MFN 06-178

Subject: **Response to NRC Request for Additional Information Letter No. 29  
Related to ESBWR Design Certification Application – Control Rod  
Drive System Structural Materials/Reactor Internal Materials &  
Integrity of Reactor Coolant Pressure Boundary – RAI Numbers 4.5-1  
through 4.5-32 and 5.2-6 through 5.2-29**

**Response to NRC Request for Additional Information Letter**

**No. 29 Related to ESBWR Design Certification Application**

ESBWR Reactor Assembly  
Showing Reactor Internal Components

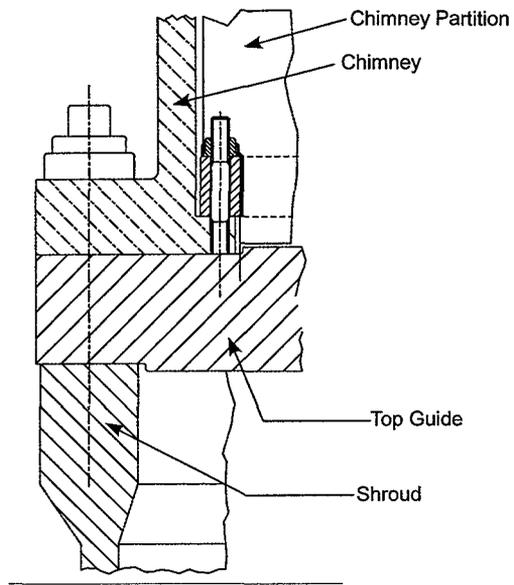
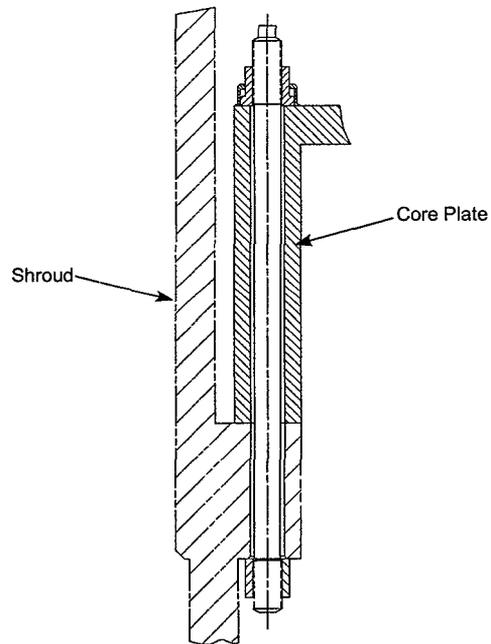
*DCD Tier 2, Section 4.5.2 contains no drawings of the core support structures nor reactor internals. Figures 4.6-1 to 4.6-10 in DCD Tier 2 contain only schematics of control rod drive mechanisms. DCD Tier 1, Figure 2.1.1-1 contains a sketch of reactor internals without details. (A) Provide the detailed drawings and/or diagrams of all significant core support structures and reactor internal components. (B) Provide assembly drawings and diagrams to show how the core support structure components and reactor internal components are attached to each other and/or to the reactor vessel. (C) Please include the drawings and diagrams in Section 4.5.2 of DCD Tier 2.*

- (A) To supplement Figure 2.1.1-1 a drawing of the reactor internals assembly is provided as shown in the following. This drawing shows the assembly of the major core structures and internal components listed in Table 4.5-1 contained in the response to RAI 4.5-1. Also, conceptual drawings of the shroud/top guide/chimney/chimney partition and the core plate-to-shroud joints are shown in the following. Sketches of other components are shown in responses to RAIs 4.5-18 Through 20.
- (B) The attached assembly drawings will be included in Section 3.9.5 in the next update of the DCD.

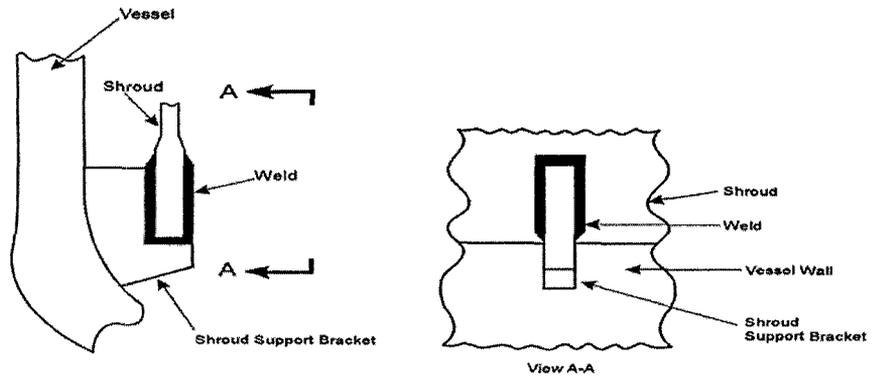
*(A) Identify the ASME Code requirements for material selection, inspection, design, fabrication, and construction of the chimney, chimney partitions, and chimney head. (B) Describe the fabrication, assembly, and installation of the chimney, chimney partitions, and chimney head. (C) Discuss whether a mockup test of the chimney assembly in a reactor vessel environment has been conducted to verify the structural integrity of the chimney assembly.*

- (C) With reference to DCD Tier 2, Appendix 3L, an air and water two-phase flow vibration test of both a 1/6-scale and a 1/12-scale model of a single chimney cell was performed. The results of the scale testing were extrapolated by a two-phase flow analysis to determine the characteristics of the pressure fluctuations acting on the partition wall of a full size cell in steam-water conditions. Stress analysis based on the test results showed an adequate margin against the allowable vibration peak stress amplitude.

**Typical ESBWR Shroud-To-Shroud Support Joint.  
12 Support Brackets Spaced Equally Around the Reactor Vessel Wall**

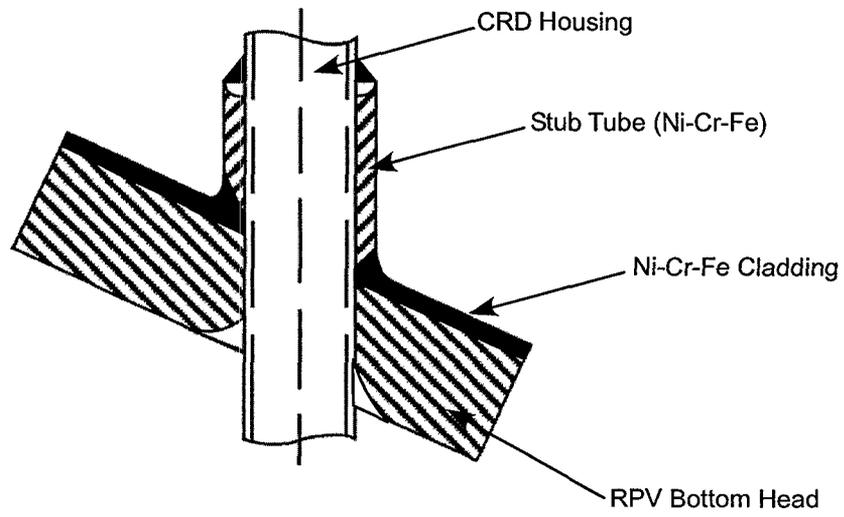
*The core shroud supports in the current BWR fleet are supported from and attached to the bottom of the reactor. The ESBWR design is attached and supported at the side wall of the reactor vessel which may result in a bending moment on the vessel wall. (A) Discuss whether the design of the core shroud supports considered the potential bending of the reactor vessel wall (i.e., the shroud supports may not sustain the loads as calculated in the structural analysis because the vessel wall may not be as rigid as assumed in the analysis). (B) Discuss whether the stress analysis of the reactor vessel shell considered the bending moment generated by the core shroud supports. (C) The core shroud supports use Niobium-modified Inconel 600 alloy. Alloy 600 material is susceptible to stress corrosion cracking. Justify the selection of this material in the reactor vessel or describe the design features that will be used to mitigate stress corrosion cracking. (D) Provide the drawings and design details including the location and installation of the core shroud supports.*

- (A) Shroud supports attached directly to the reactor vessel wall were used in the past in vessels built by Combustion Engineering; e.g., Plant Hatch. Analyses and experience have proven that the bending stresses produced by the cantilever shroud support design in these vessels are acceptable.

- (C) The core support material is Ni-Cr-Fe Alloy 600 with columbium added. (Note columbium is frequently called niobium outside the U.S.). Use of this material is permitted by ASME Code Case N-580-1. Columbium modified Ni-Cr-Fe Alloy 600 has been successfully used in the ABWRs, and tests have shown it is highly resistant to stress corrosion cracking in a BWR environment.

Typical Lateral Support Connection To Lower Shroud

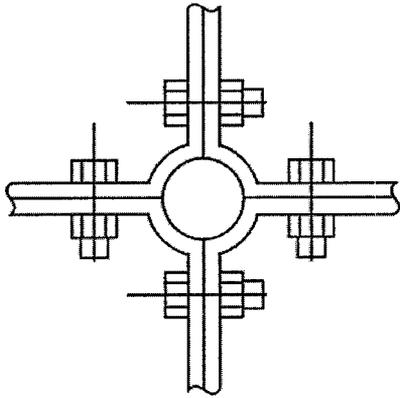
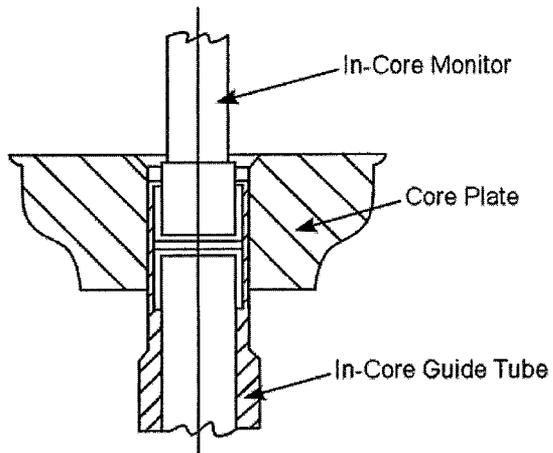
*Section 2.1.1 in DCD Tier 1 states that a latticework of clamps, tie bars, and spacers provide lateral support and rigidity to the in-core guide tubes. (A) Provide assembly drawings of the lateral support components, in-core guide tubes, how the lateral support components are inter-connected, and how the in-core guide tubes are attached to the shroud. The drawings should be included in Section 4.5.2 in DCD Tier 2. (B) Identify materials used for the lateral support components and in-core guide tubes. (C) Identify the number of penetrations.*

- (A) The lower ends of the in-core guide tubes are welded to the in-core housings in the bottom of the reactor vessel. The top ends extend through holes in the core plate that provides lateral support. Conceptual drawings illustrating the interconnections between the in-core guide tubes lateral supports and their attachments to the lower portion of the shroud, and the connections between the guide tubes and the core plate will be included in Section 3.9.5 of DCD Tier 2. The figures to be included are shown below.
- (B) The material of the lateral supports and the in-core guide tubes is shown in the revised Table 4.5-1 contained in the response to RAI 4.5-1.
- (C) There are a total of 88 in-core penetrations in the reactor vessel bottom head. The locations of the penetrations within the core are shown on Figures 7.2-6 and 7.2-7 of DCD Tier 2.

Figure 5.2-1. Safety/Relief Valve Schematic Elevation

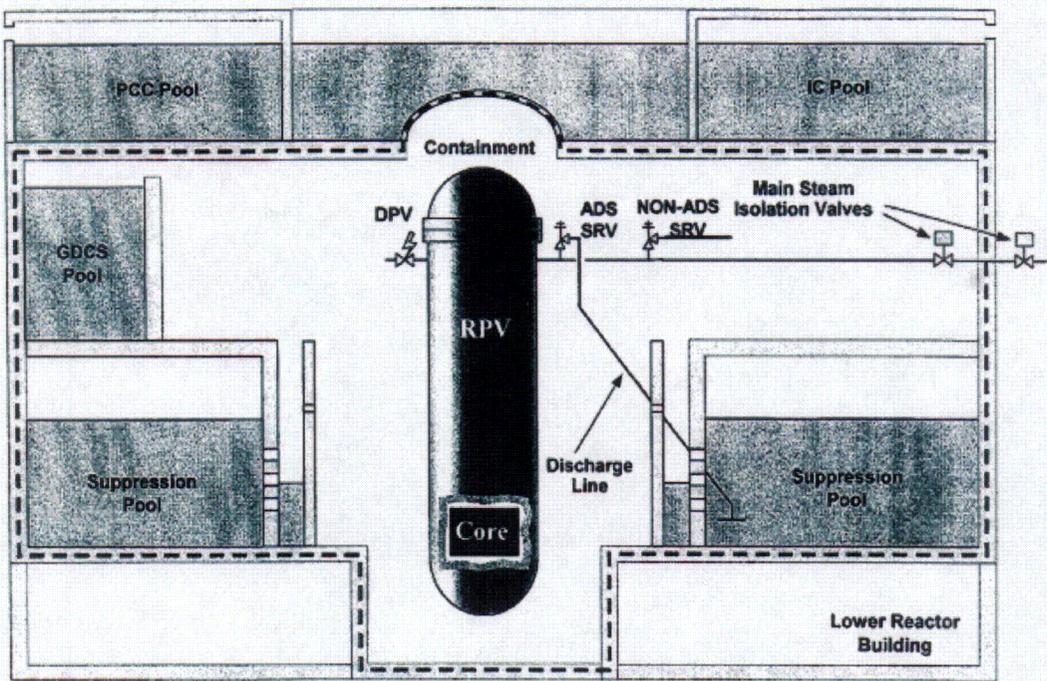
*DPVs and non-ADS SRVs are discharged into the drywell. Is there any safety grade equipment in the drywell which is required for safe shutdown of the plant which will be affected by the DPV and SRV discharge into the drywell?*

The location of all equipment in the Drywell has not been finalized at this time. However, according to the current arrangement of major equipment in the Drywell, there is no safety grade equipment required for safe shutdown of the plant that is affected by DPV or Non-ADS SRV discharge. As the process continues to locate all equipment, safety grade equipment required for safe shutdown of the plant will not be located in a position that is affected by DPV or non-ADS SRV discharge in the Drywell. Clarification will be provided on DCD Figure 5.2-1 to show that Non-ADS SRVs discharge to the Drywell. DCD Figure 5.2-1 will be revised in the next update as noted in the attached markup.
